ROAN ESTATES SUBDIVISION

APPLICATION NUMBER 6 DATE March 23, 2017

REQUEST Subdivision

DETAIL SITE PLAN

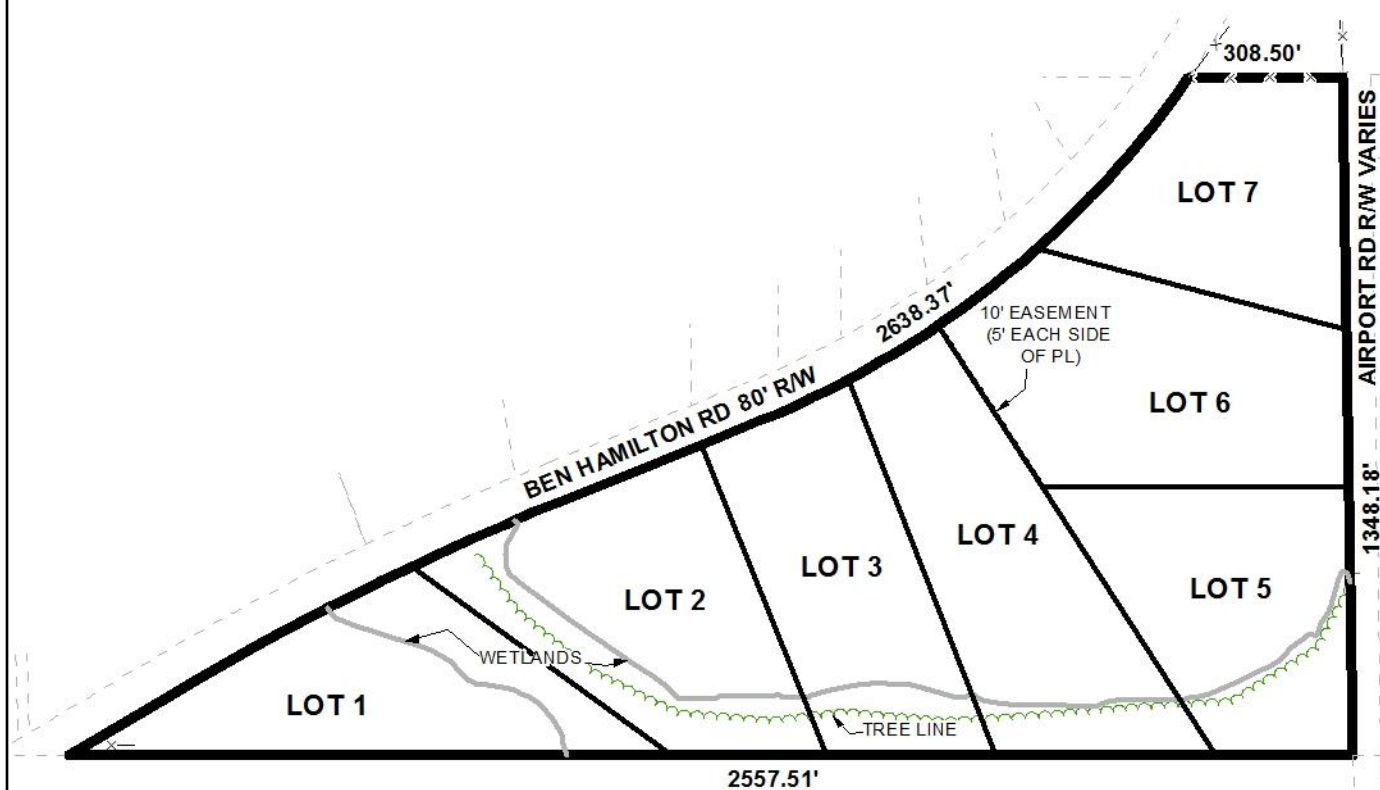
Proposed Lots 1-4 have frontage on to Ben Hamilton Road, a minor street without curb and gutter requiring a 60' right-of-way; proposed Lot 5 has frontage on to Airport Road, a planned major street requiring 120' of right-of-way; and proposed Lots 6 and 7 have frontages on both Ben Hamilton Road and Airport Road. The preliminary plat illustrates adequate right-of-way along Ben Hamilton Road, but the plat should be revised to provide adequate dedication to provide dedication 60' from the centerline of Airport Road, as needed, to satisfy the intentions of the Major Street Plan.

Each lot meets the minimum size requirements of the Subdivision Regulations for lots served by public water and individual septic systems; however, the lot sizes are provided only in acres. As such, revision of the plat to illustrate the size of each lot in both square feet and acres should be required; or, a table illustrating the same information should be provided on the Final Plat, if approved.

With regards to access management, a note should be placed on the Final Plat, if approved, stating: Lots 1-4 are each limited to two curb cuts to Ben Hamilton Road; Lot 5 is limited to two curb cuts to Airport Road; and Lots 6 and 7 are each limited to two curb cuts to Ben Hamilton Road, and two curb cuts to Airport Road, with any changes in their sizes, locations, or designs, to be approved by County Engineering and conform to AASHTO standards.

The 25' minimum building setback line is not illustrated along any street frontages; therefore, the plat should be revised to illustrate the 25' minimum building setback line along all street frontages, adjusted for any additional dedication(s), if approved.

A 10' utility easement is illustrated between proposed Lots 4, 5 and 6; therefore, if approved, a note should be required on the Final Plat stating no structures may be built in any easement.

Wetlands have been identified between proposed Lots 1 and 2, and along the southern portions of Lots 2-5; and, as such, may indicate the area is environmentally sensitive. Therefore, approval from all applicable federal, state, and local agencies may be required prior to the issuance of any permits or land disturbance activities.

This site is located in the County, thus any lots which are developed commercially and adjoin residentially developed property must provide a buffer, in compliance with Section V.A.8. of the Subdivision Regulations. A note regarding this requirement should also appear on the Final Plat, if approved.

Finally, the site will have to comply with the City of Mobile storm water and flood control ordinances. A note stating: *"Must comply with the Mobile County Flood Damage Prevention Ordinance. Development shall be designed to comply with the storm water detention and drainage facility requirements of the City of Mobile storm water and flood control ordinances, and requiring submission of certification from a licensed engineer certifying that the design complies with the storm water detention and drainage facility requirements of the City of Mobile storm water and flood control ordinances prior to the issuance of any permits."* should be placed on the Final Plat.

- 1) revision of the plat to illustrate, where necessary, dedication to provide 30' from the centerline of Airport Road;
- 2) revision of the plat to illustrate the lot sizes of each lot in square feet and acres on the, or the furnishing of a table on the Final Plat providing the same information;

- 3) placement of a note on the Final Plat stating: Lots 1-4 are each limited to two curb cuts to Ben Hamilton Road; Lot 5 is limited to two curb cuts to Airport Road; and Lots 6 and 7 are each limited to two curb cuts to Ben Hamilton Road, and two curb cuts to Airport Road, with any changes in their sizes, locations, or designs, to be approved by County Engineering and conform to AASHTO standards;

- 4) revision of the plat to illustrate the 25-foot minimum building setback line along all street frontages;
- 5) placement of a note on the Final Plat stating no structures may be built in any easement;

- 6) placement of a note on the Final Plat stating that any lots which are developed commercially and adjoin residentially developed property must provide a buffer, in compliance with Section V.A.8. of the Subdivision Regulations;

- 7) placement of a note on the Final Plat to comply with the Mobile County storm water and flood control ordinances: *(Must comply with the Mobile County Flood Damage Prevention Ordinance. Development shall be designed to comply with the storm water detention and drainage facility requirements of the City of Mobile storm water and flood control ordinances, and requiring submission of certification from a licensed engineer certifying that the design complies with the storm water detention and drainage facility*

requirements of the City of Mobile storm water and flood control ordinances prior to the issuance of any permits.); and,
